## ADDENDUM

**ADDENDUM NO.:** 04  
**PROJECT NAME:** Emergency Medical Services (EMS) Addition  
**PROJECT NO.:** 07215  
**CONTRACT NO.:** C1611  
**DATE OF ISSUE:** July 31, 2024

### NOTICE OF CHANGES, MODIFICATIONS, OR CLARIFICATIONS TO CONTRACT DOCUMENTS

3 | 271513 HORIZONTAL CABLING NTS

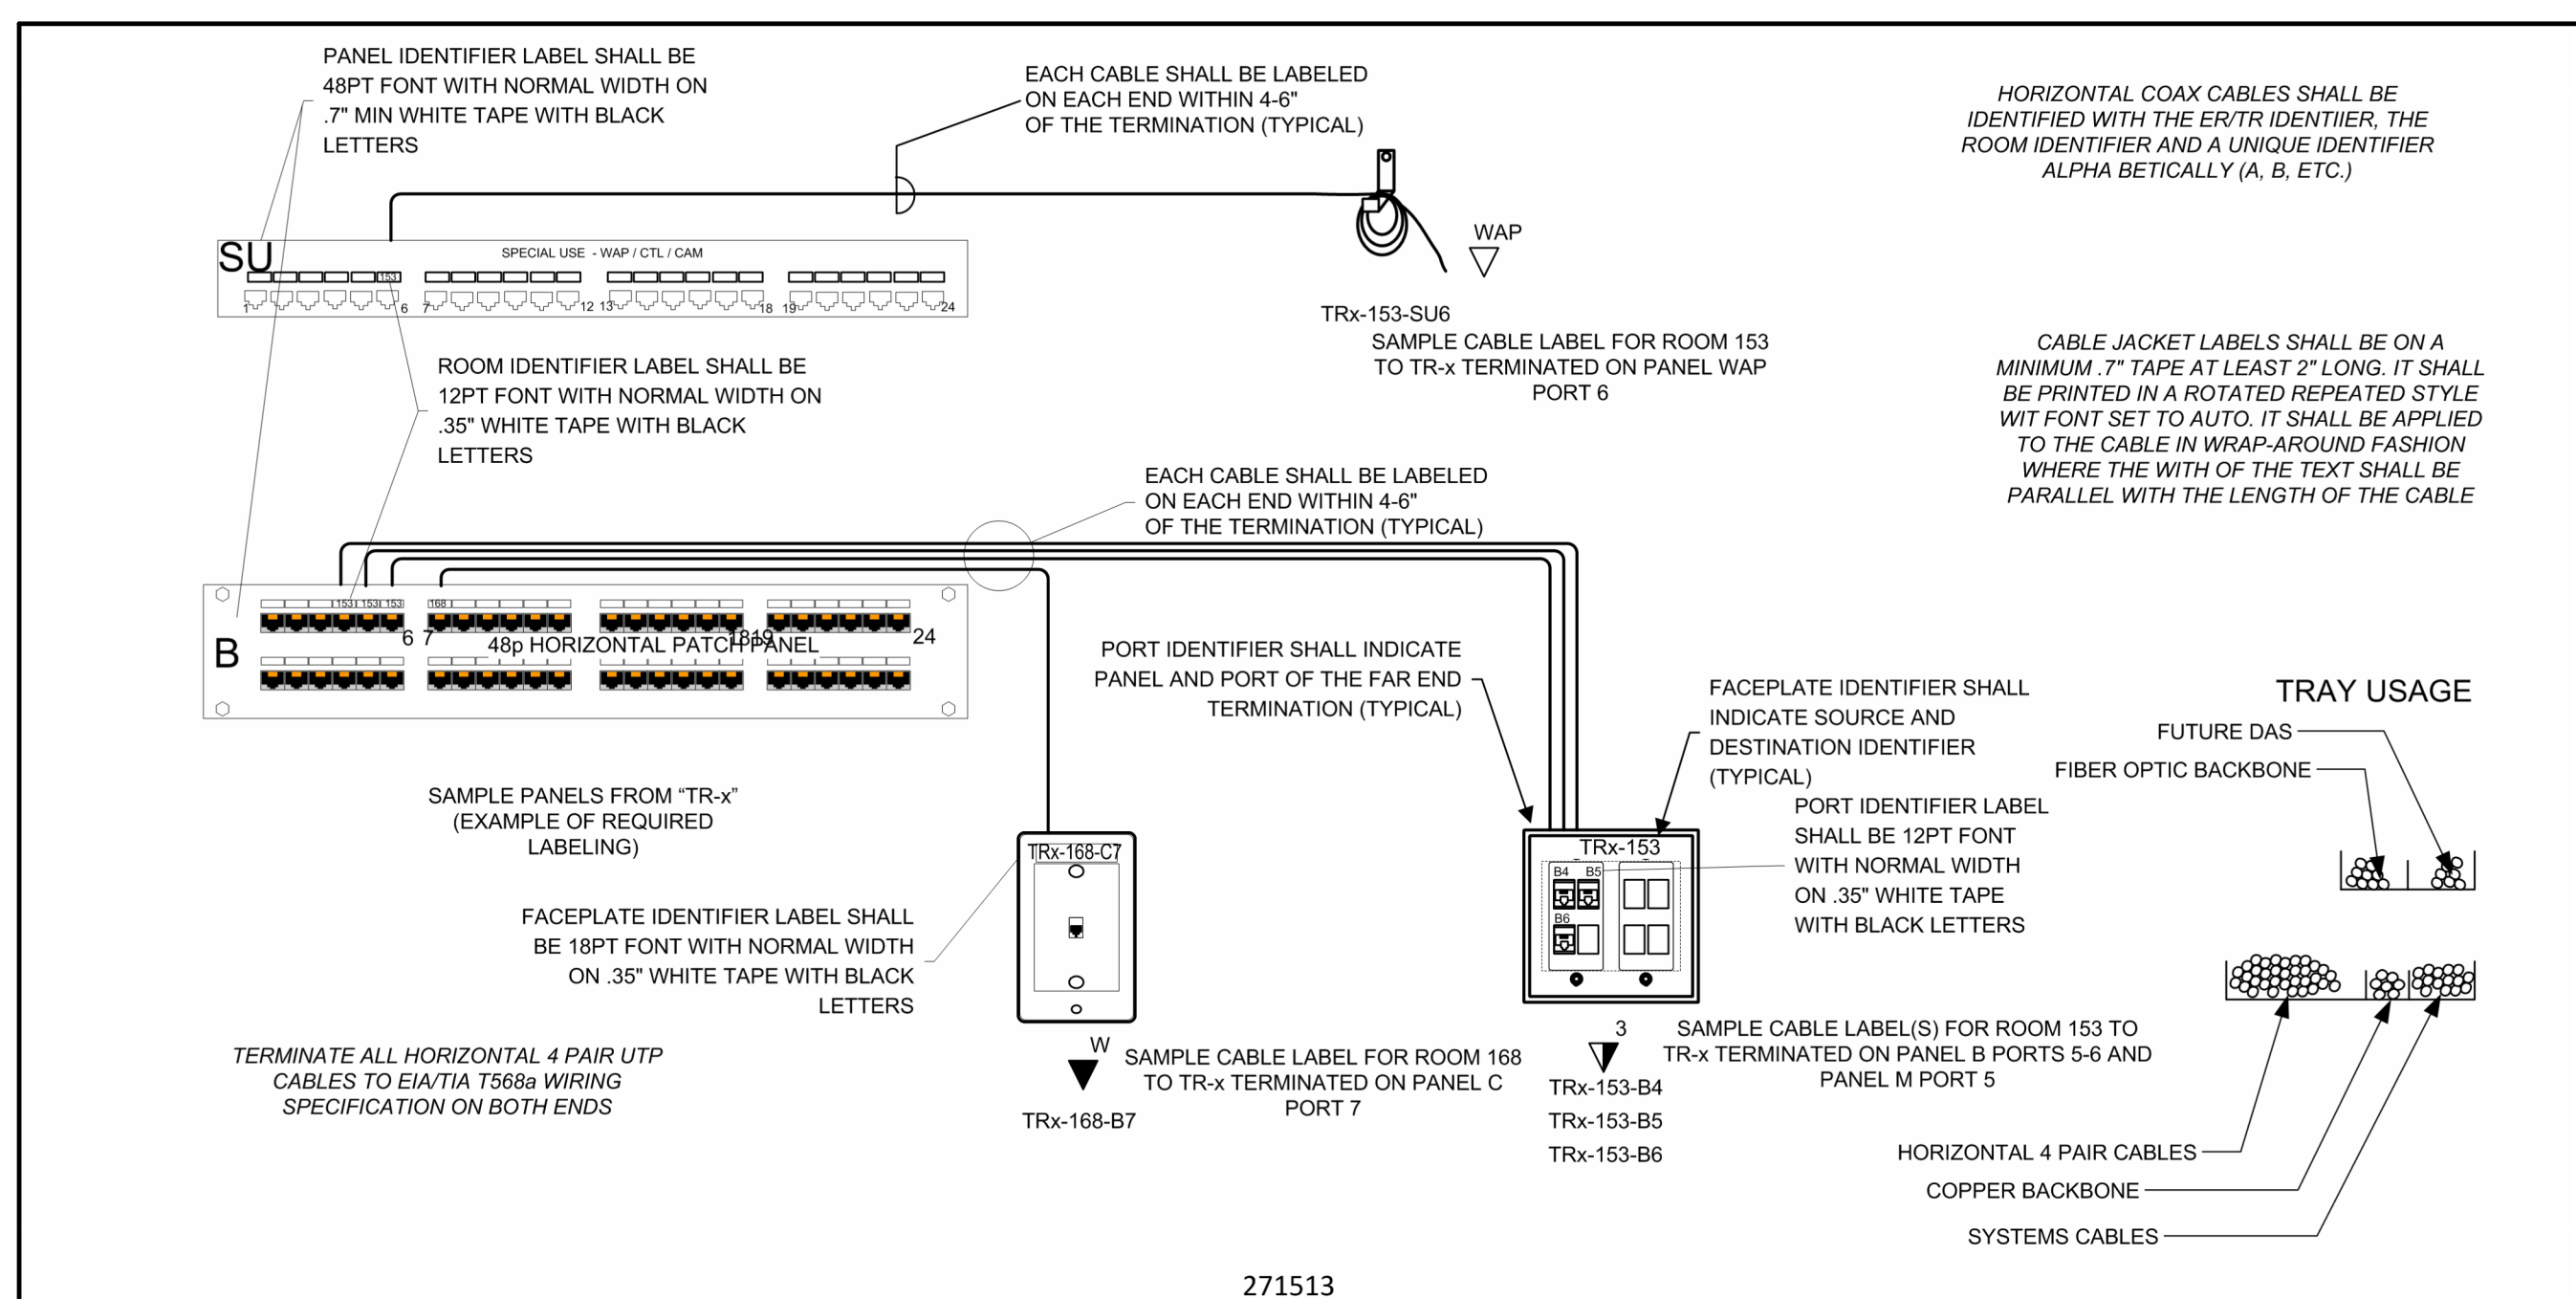
- Change 32** **REVISED** Drawing Nos. T110, T120 & T130 – Re-positioned/added Voice/Data outlets, changed AV equipment and updated room types.
- Change 33** **REVISED** Drawing No. T502 – Updated Details 4 & 9.
